Access Compliance Report

Public Rights-of-Way

(Curb Ramps)

Intersection ID: 6987	Main Street: W_ROCKY_RIVER_RD	Cross Street: ROCKLAND_DR	Location: NE
ADA ID: 42B9818A5B01	Ramp Type: Perp	Initial Pass/Fail: Fail	Overall Compliance: No
Severity Score: 13.75			
Codes/Mitigation Info/Possible Solution		Field Measurements/Component Compliance

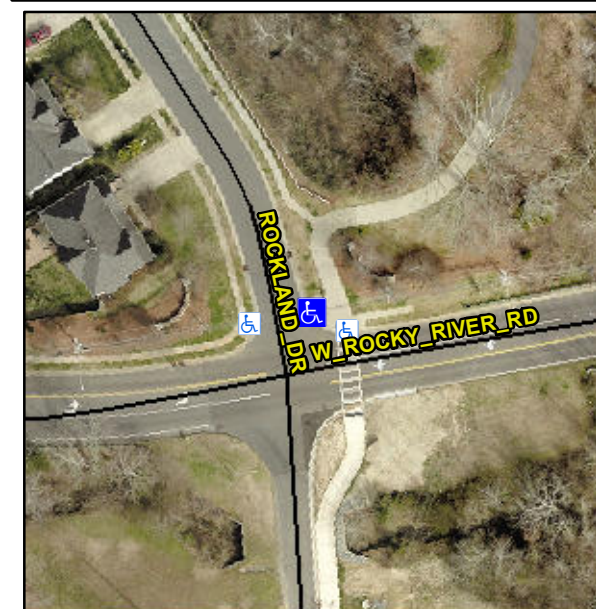
Not Found, R304.2.2, R304.5.3

Compliance	Description	Data	Compliance	Description	Data
N/A	Ramp Length (in)	98.0	No	Ramp Slope (%)	8.6
Yes	Ramp Width (in)	48.0	No	Ramp XSlope (%)	4.1
N/A	Flare Type LT	N/A	N/A	Flare Type RT	N/A
N/A	Flare Slope LT (%)	N/A	N/A	Flare Slope RT (%)	N/A
N/A	Flare Traversable LT?	N/A	N/A	Flare Traversable RT?	N/A
N/A	Landing Length (in)	N/A	N/A	DWS Provided?	N/A
N/A	Landing Width (in)	N/A	N/A	DWS Contrast?	N/A
N/A	Landing Slope (%)	N/A	N/A	DWS Length (in)	N/A
N/A	Landing X Slope (%)	N/A	N/A	DWS Full Width?	N/A
N/A	Landing Curb? (Y/N)	N/A	N/A	DWS Offset (in)	N/A
N/A	Shared Landing?	N/A			
N/A	Gutter Ponding?	N/A	N/A	Gutter Slope (%)	N/A
N/A	Gutter Lip Ht (in)	1.0	N/A	Gutter X Slope (%)	N/A
N/A	Painted X Walk1?	No	N/A	Painted X Walk2?	N/A
	X Walk 1 Direction	To W		X Walk 2 Direction	N/A
N/A	X Walk 1 Width (in)	N/A	N/A	X Walk 2 Width (in)	N/A
	X Walk 1 Slope (%)	3.5		X Walk 2 Slope (%)	N/A
	X Walk 1 X Slope (%)	3.5		X Walk 2 X Slope (%)	N/A

Remove & Replace Entire Ramp.
